DAIRYLAND POWER
C O O P E R A T I V E

SUBJECT: Dairyland Power Cooperative
La Crosse Boiling Water Reactor (LACBWR)
Request for Amendment to 10 CFR 50, Possession-Only License in Support of
Dry Cask Storage Project

Attachment 1

Evaluation of Proposed Changes

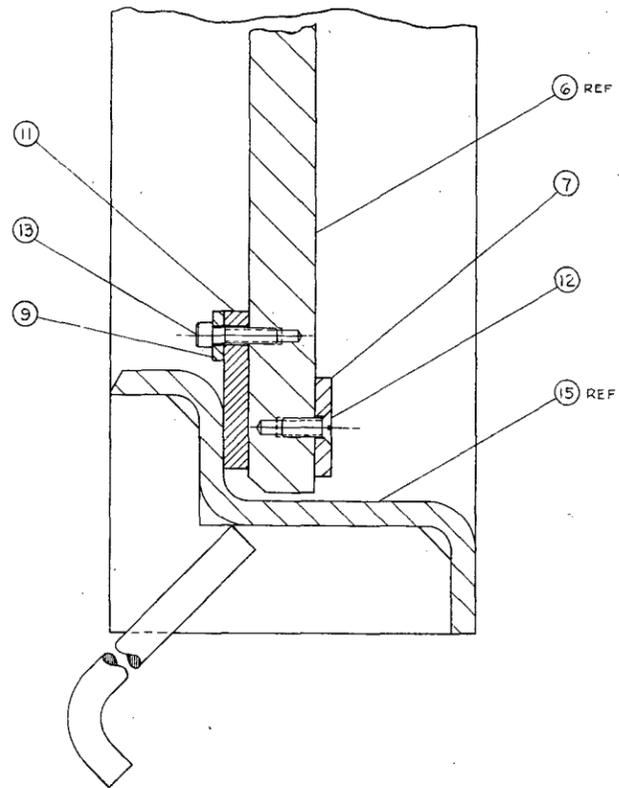
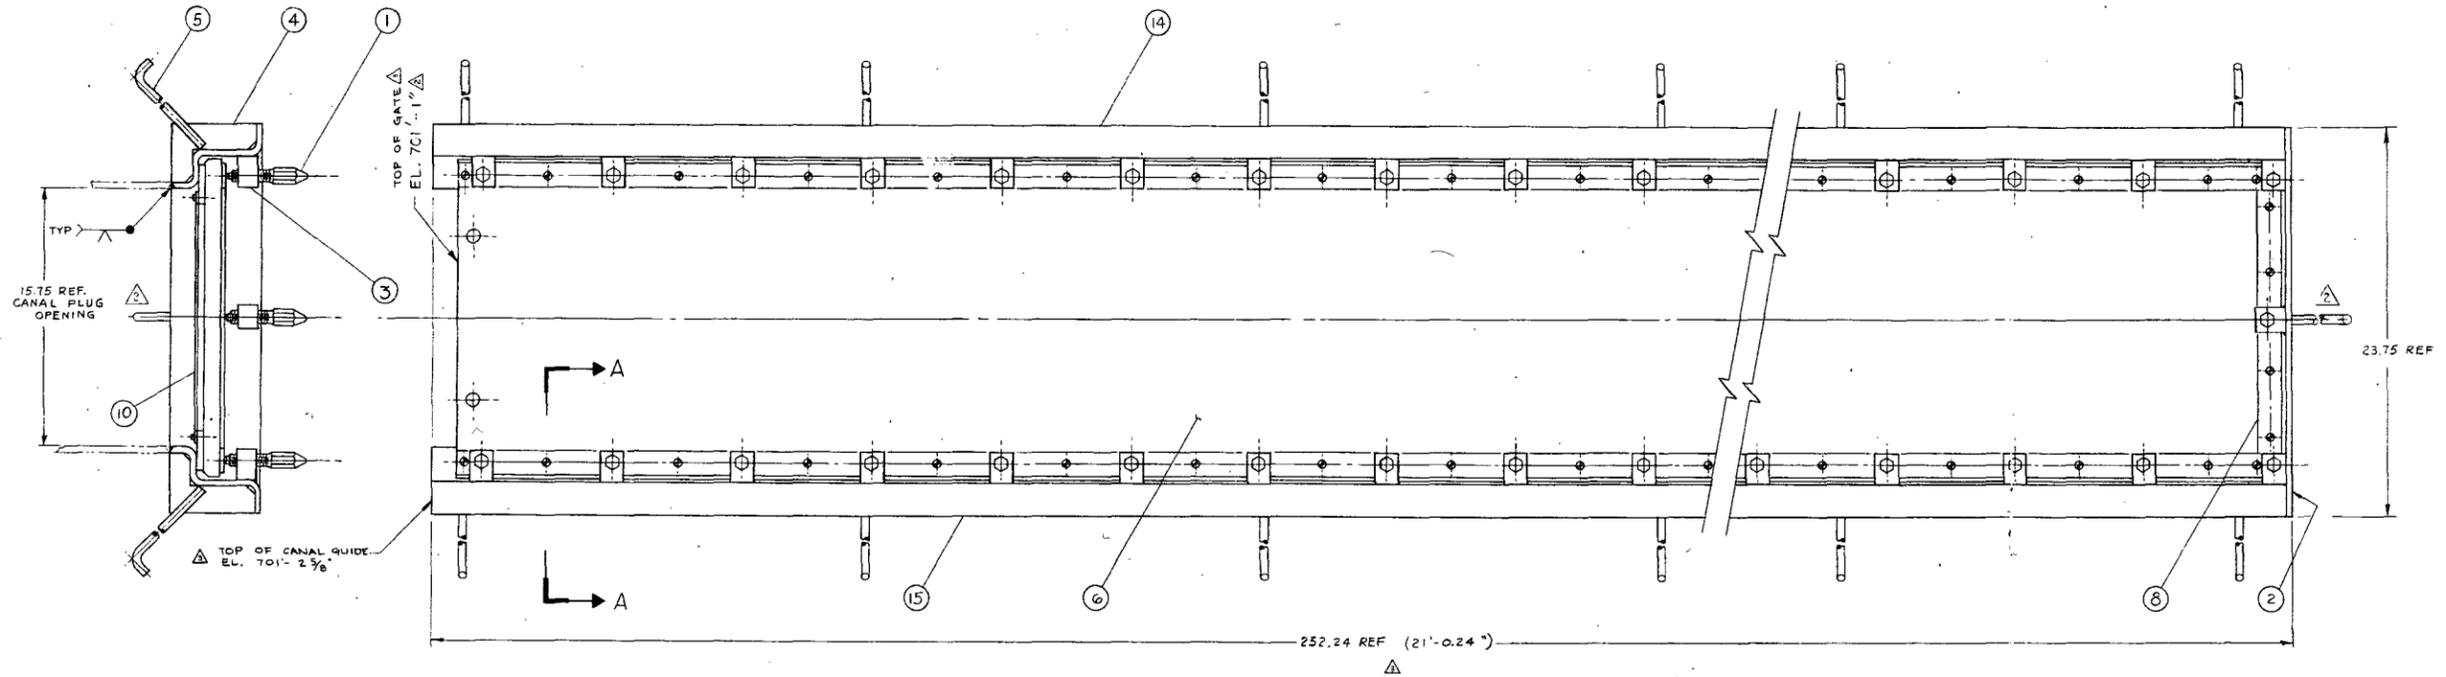
Refer to Reference 3 for the following discussion. The LACBWR FESW is 11 feet wide by 11 feet long by 42 feet deep and contains 333 fuel assemblies in a two-tiered storage rack configuration. At present, 114 fuel assemblies are stored in the upper tier racks and 219 assemblies are stored in the lower tier racks. The bottom floor of the FESW is at elevation 659'-5-5/8". The top of the active fuel in the upper tier rack is at elevation 677'-2-1/8". Normal water level in the FESW is maintained at elevation 695 feet or higher in order to comply with the 16 feet minimum water coverage of the irradiated fuel in the upper tier racks required by current TS LCO 4.1.2.a with some operating margin. The fuel transfer canal, sealed by a removable gate, is located in the FESW north wall and has a bottom elevation of 680'-5". The transfer canal gate must be removed to move fuel assemblies from the wet storage racks to the spent fuel canister in the cask pool during cask loading operations, and during movement of dummy assemblies used for dry run training.

The current 16 feet minimum water coverage LCO requires FESW water level to be maintained at or above elevation 693'-2-1/8" with fuel in the upper tier racks, and elevation 684'-2-1/2" with all fuel in the lower tier racks. Both of these water coverage elevations are above the 680'-5" elevation of the bottom of the transfer canal, necessitating the installation of the transfer canal gate to meet the current LCO. DPC proposes to reduce the 16 feet minimum water coverage over irradiated fuel to 10 feet. The 10 feet water coverage LCO would result in a minimum required FESW water level 687'-2-1/8" with any fuel in the upper tier racks and 678'-2-1/2" with all fuel in the lower tier racks.

Because the 10 feet water coverage requirement with fuel in the upper tier racks would still result in a minimum required water level above the bottom elevation of the transfer canal, a limited exception to the revised LCO 4.1.2.a. is also requested in a proposed new LCO 4.1.2.c. (described in more detail in Section 'c' below). This exception would allow reduced water level coverage for times limited in duration with fuel in the upper tier racks, making it possible to avoid having to install the transfer canal gate at any time during dry run training activities in the cask pool through actual cask loading operations. With all fuel in the lower tier racks, the minimum required water coverage of 10 feet per revised LCO 4.1.2.a. would be below the transfer canal bottom elevation and permit the transfer canal gate to remain uninstalled for the remainder of cask loading operations. The 10 feet water coverage limit provides adequate shielding for personnel as discussed in more detail below.

New LCO 4.1.2.c. proposes to permit the FESW water level to be maintained at least 2'-9" above the irradiated fuel in the upper tier storage racks, i.e., elevation 679'-11-1/8" or higher. There are currently 114 spent fuel assemblies stored in the upper tier racks. The 2'-9" minimum water coverage was chosen because recent dose rate measurements (Reference 6) and evaluations (Reference 9) show that adequate shielding is provided for the working floor with water level at the lowered elevation. Administratively, water level will be lowered, as visually verified, to slightly below the transfer canal bottom, allowing the transfer canal gate to be left uninstalled and preventing significant spillover of water into the cask pool during and after draining. It is expected that the water level would be held at approximately elevation 680'-3" during this time.

The lower minimum FESW water level slightly below elevation 680'-5" with fuel in the upper tier racks will reduce the level of water by about 15 feet and the total volume of water in the FESW by approximately 14,000 gallons. The reduction in volume will have no effect on operation of the FESW cooling system because flow rate and cooling capacity of the system remain unchanged. Decay heat of the fuel has decreased dramatically since the plant was permanently shut down more than 22 years ago; total current heat production of the irradiated fuel inventory is estimated to be approximately 12.2 kW or 41,600 BTU/hr. The lower water level with fuel in the upper tier racks ensures the suction line for the FESW cooling water pumps with centerline at elevation 679 feet remains submerged and adequate net positive suction head for the pumps is maintained.

Administrative controls will require water level to be lowered to slightly below the bottom of the transfer canal. Visual verification of water level clearing the transfer canal bottom will ensure FESW suction remains available and the FESW cooling system will continue decay heat removal uninterrupted. To avoid potential vortexing issues, the 4-inch diameter skimmer line with centerline at elevation 679'-11" will be prohibited from being used by administrative controls with the pool at lowered level (see Reference 3).

LACBWR
CANAL GATE AND HOUSING

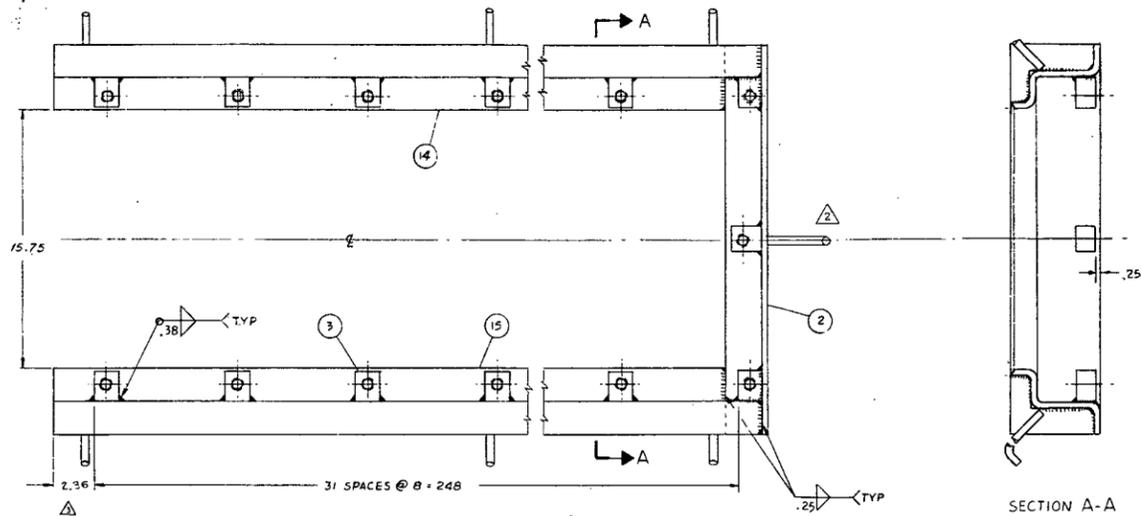
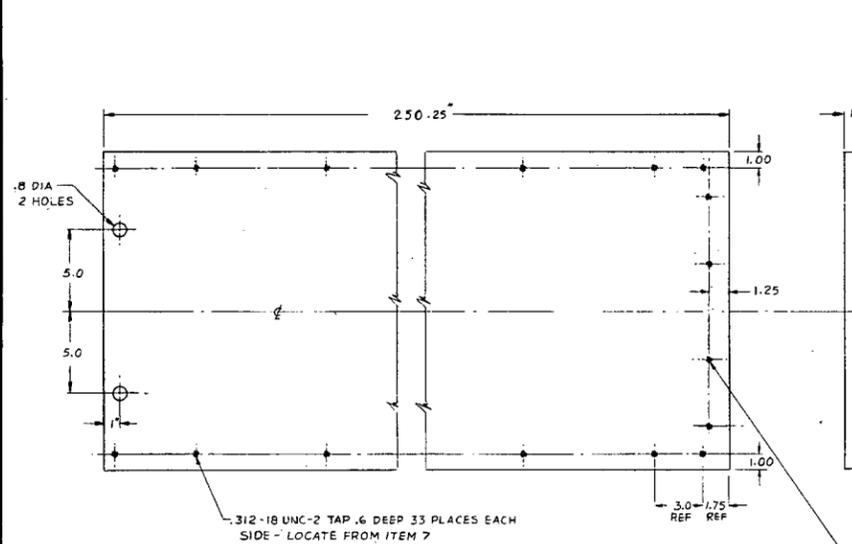
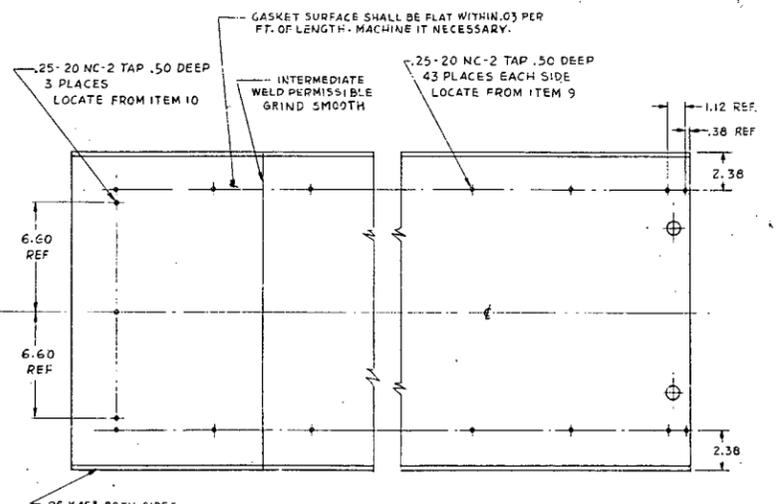
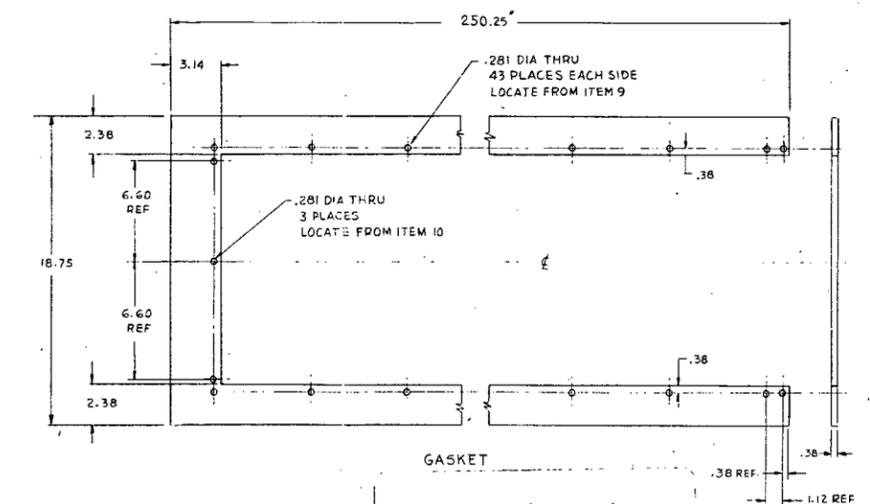
The transfer canal gate is held in place by 65 threaded jacking bolts that compress the gate onto the sealing surface (References 4 and 5). Each bolting and unbolting operation requires use of a long-handled manual ratchet tool and takes significant time, estimated to be 6 hours, and a five person work crew. Such transfer canal gate operations would cause these personnel to incur unnecessary occupational dose if LCO 4.1.2.a. were to remain unchanged. Moreover, the fuel transfer canal gate has not been removed in 22 years, presenting a significant operational risk of not being able to obtain a watertight seal each time the gate is installed. Repairs and potential seal replacements would incur additional radiation exposure to personnel if the gate was not to seal properly after one or more reinstallations.
